L73X-
A.05.19

To: Official After-Sales Network
Subject: Installation of air ducts on the floor panel
Date: 29 Friday 2019
Pages 4

Campaign Description:
Installation of 2 air ducts on the floor panel

Model:
Aventador

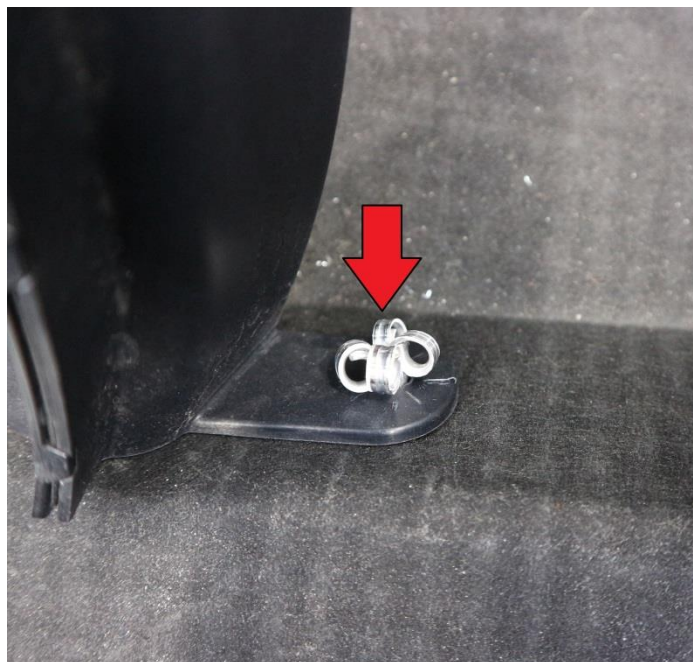
- VAS 6759 riveter or equivalent tool.
2. Position the air intake near the opening on the panel and the hole.

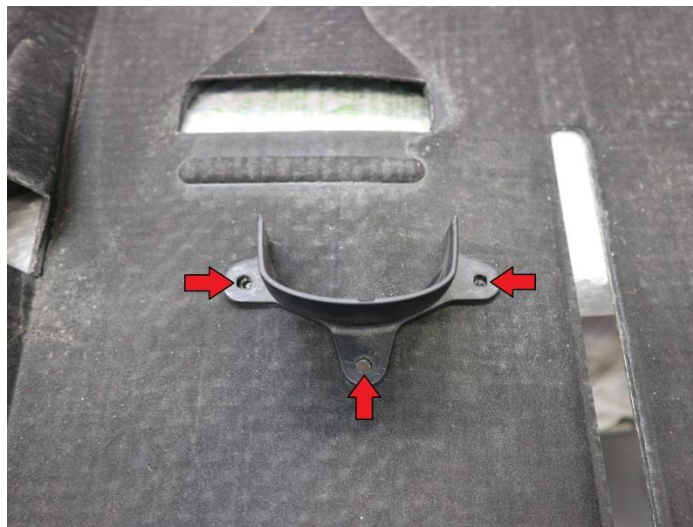
3. Position the rivet and secure it with the riveter.

4. Position the air intake near the 3 holes.

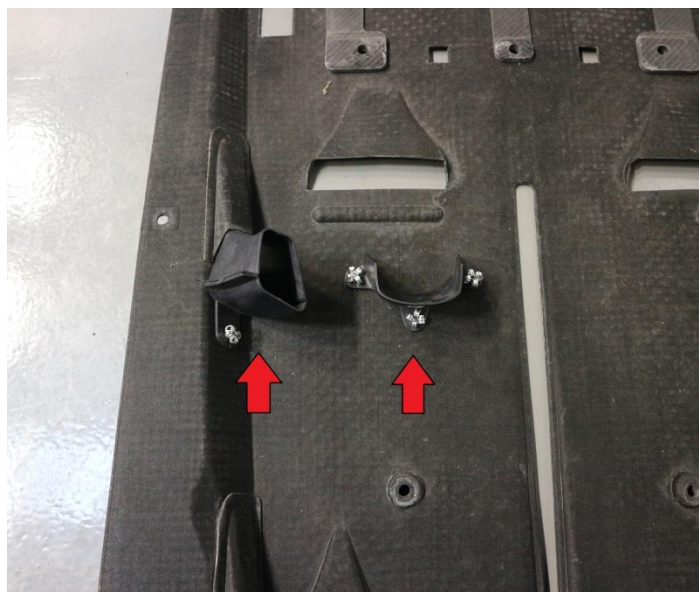
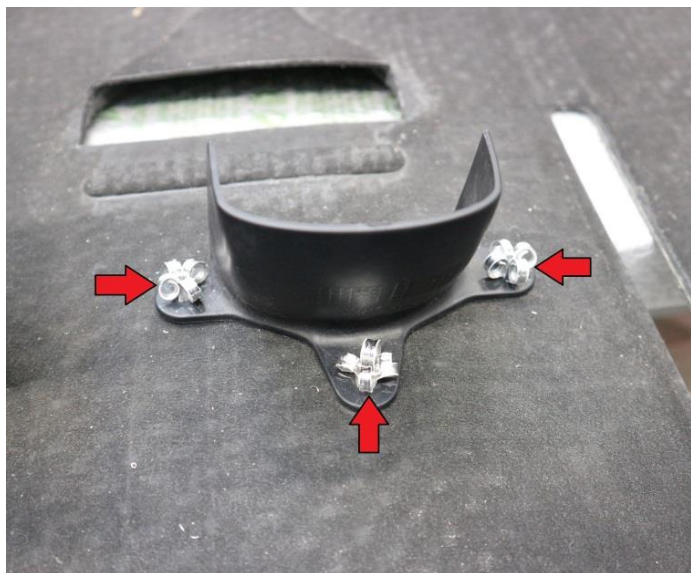
5. Position the 3 rivets and secure them with the riveter.
6. Installation completed:
